# Kalmus Beach, Bathhouse and Parking Lot

## ADA Transition Plan

October 2021

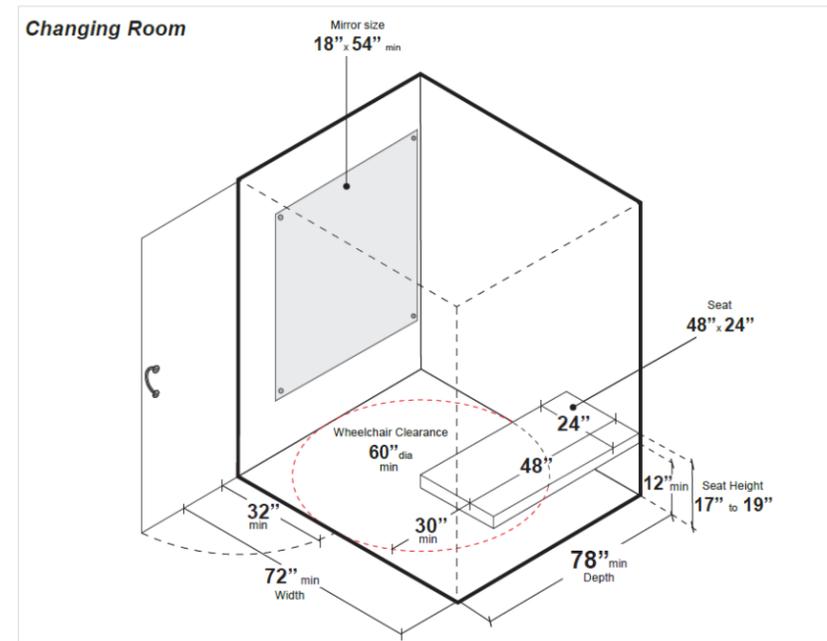
**Note:** The pavilion has newer picnic tables but they lack the required 19" knee clearance. See fig. below.

Fig. 1: Accessible changing room

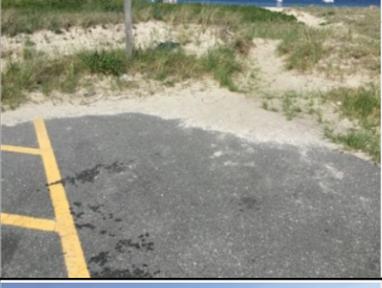
Accessibility issues at the changing rooms includes lack of an accessible changing room. That includes lack of the minimum required turning space, lack of a clear floor space adjacent to the bench and coat hooks higher than the maximum height allowed. See Fig. 1 at the end of this report for an example of an accessible changing room.
